BIDDING ADDENDUM NO. 06

JOHNSON CITY CENTRAL SCHOOL DISTRICT

JCCSD CAPITAL PROJECT PHASE 2

HA PN 2024-239P

TOILET ROOMS 122/123
ELECTRICAL RENOVATION PLAN

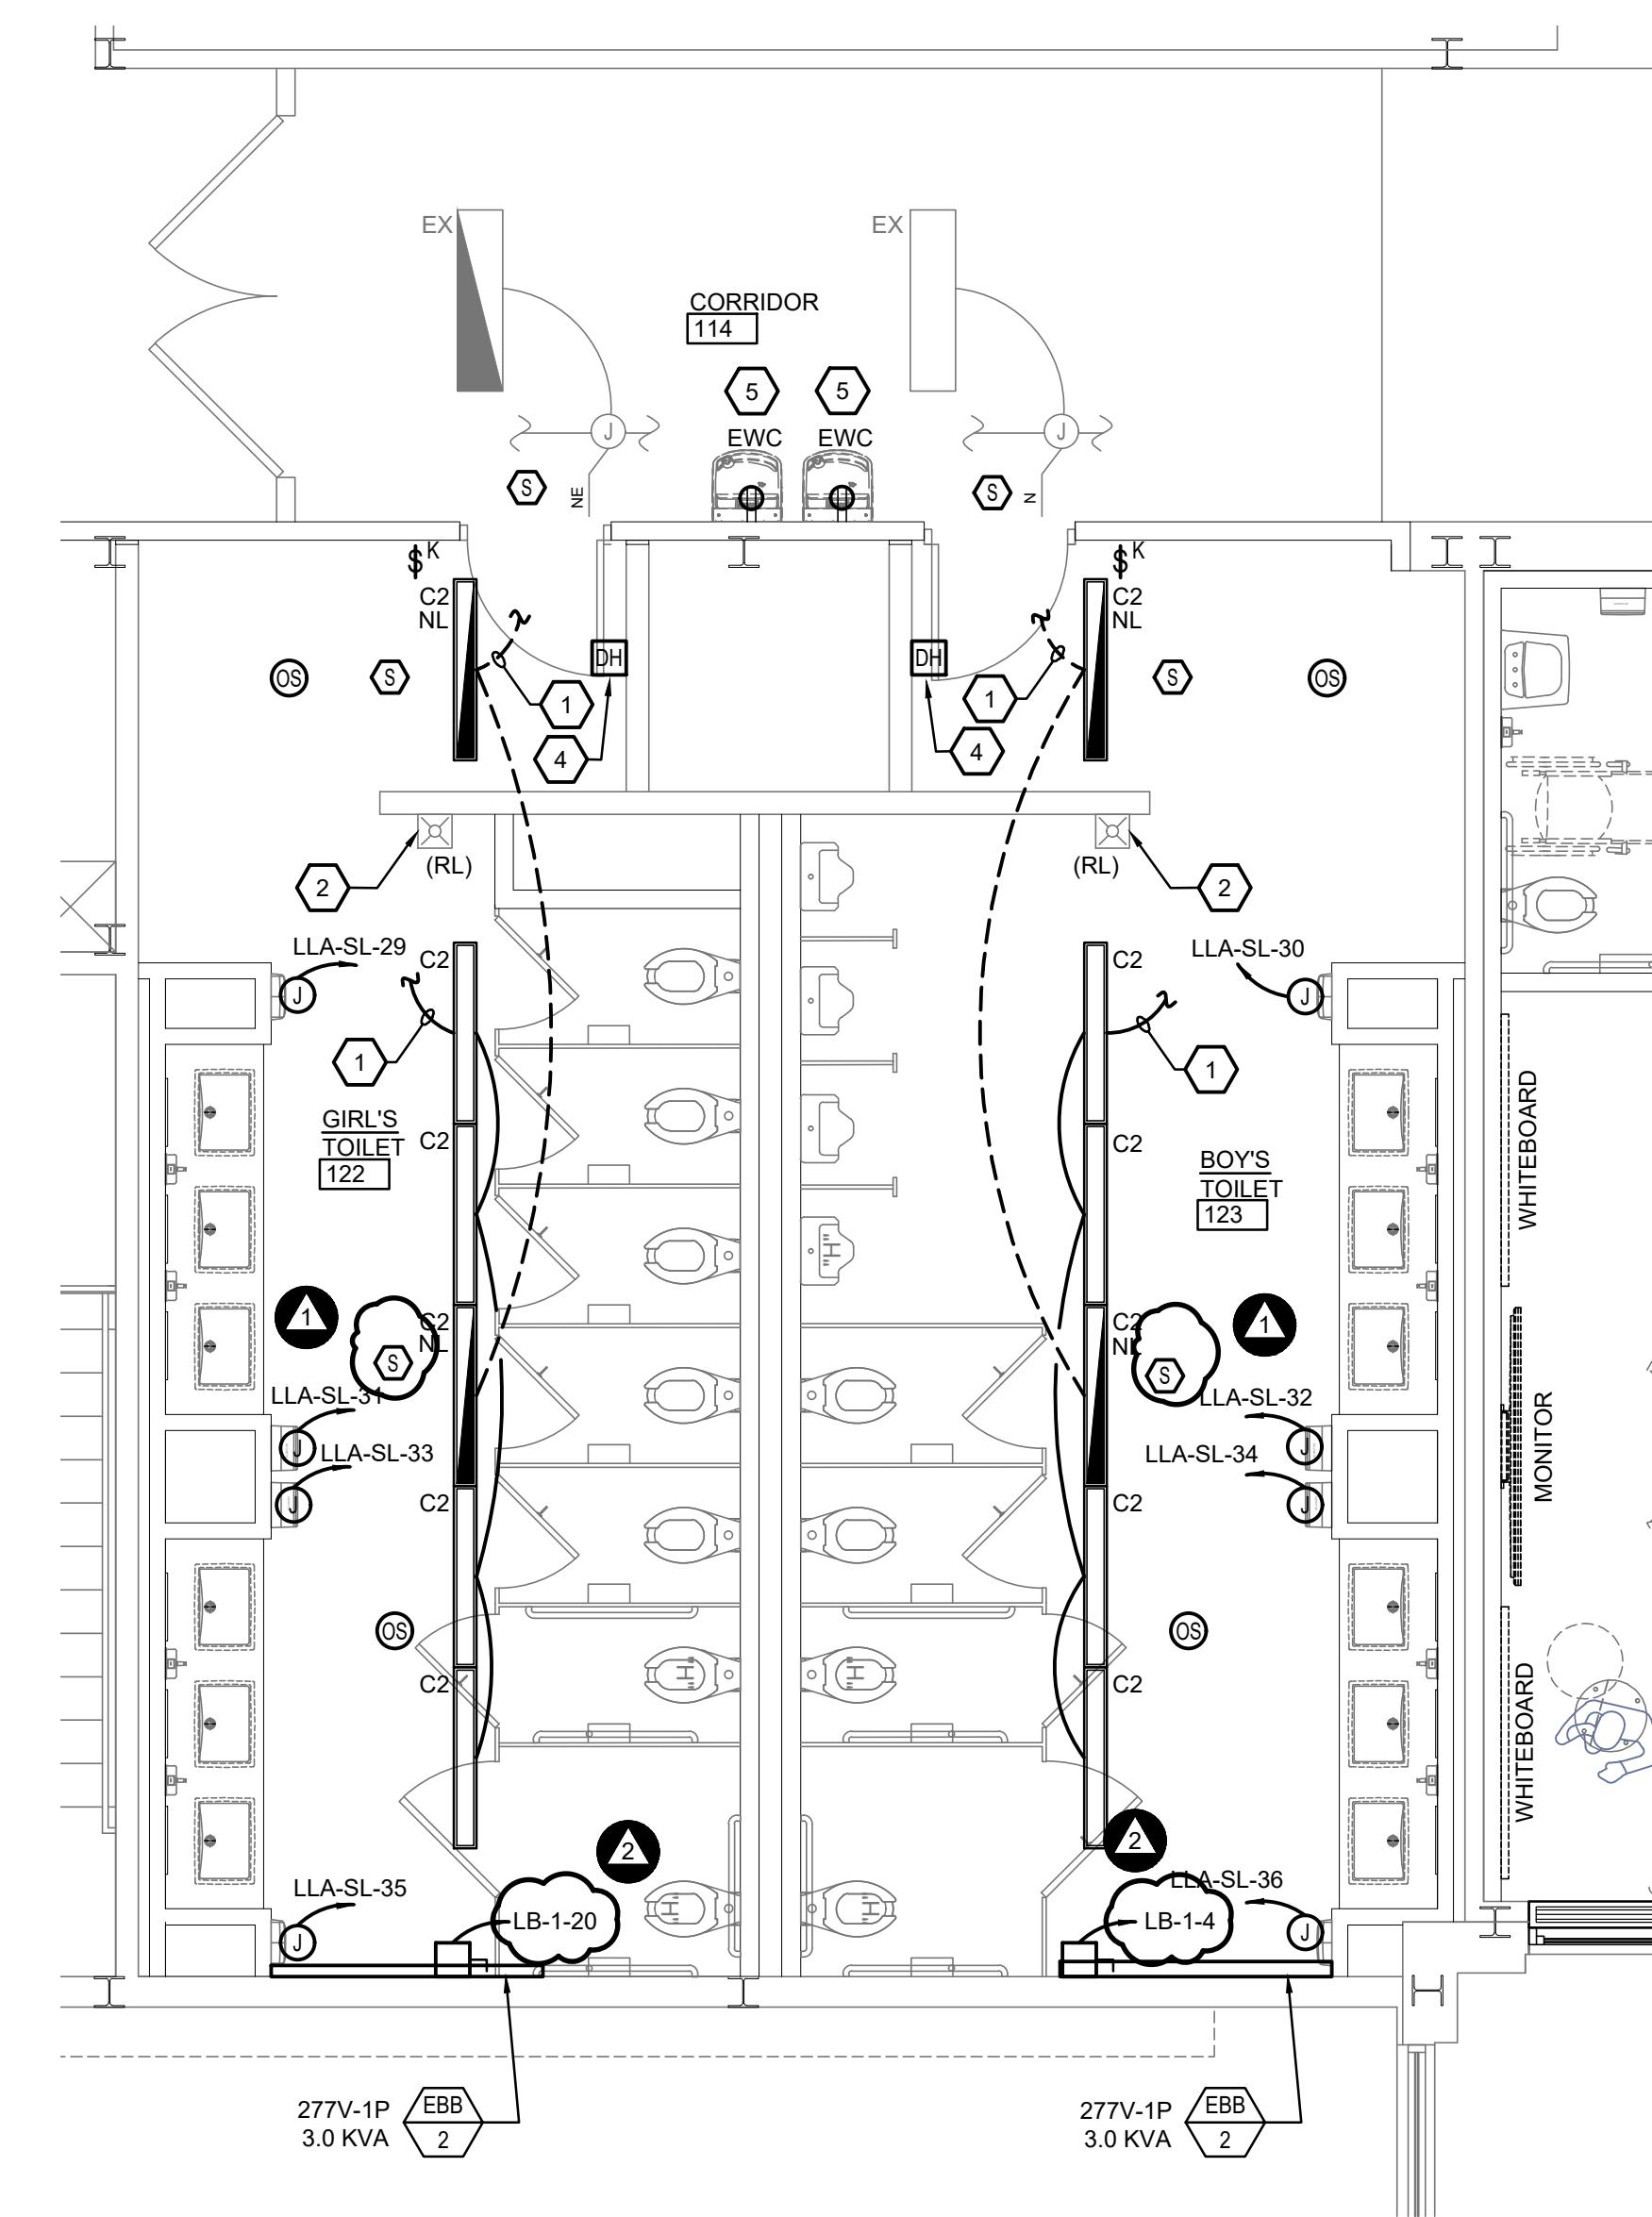
Request: Can you please verify the exact location of panelboard "LA"? Drawing HS E-105 shows two circuits feeding electric baseboard heaters from this panel and I'm unable to find its location anywhere within the construction documents.

- A. HS E-105
 - 1. Revised Baseboard Circuit Numbers
- B. HS E-401
 - 1. Added Panel LB-1

ANSWER: The panel circuit number in Toilet Rooms 122 and 1213 indicated 'LA' on E-105 should read "LB-1" and is located in corridor. The baseboard heat in these rooms should be fed to this panel. Refer to First Floor Composite Plan on HS E-004 for panel location and HS E-401 for Panel Schedule. Revised drawings attached.
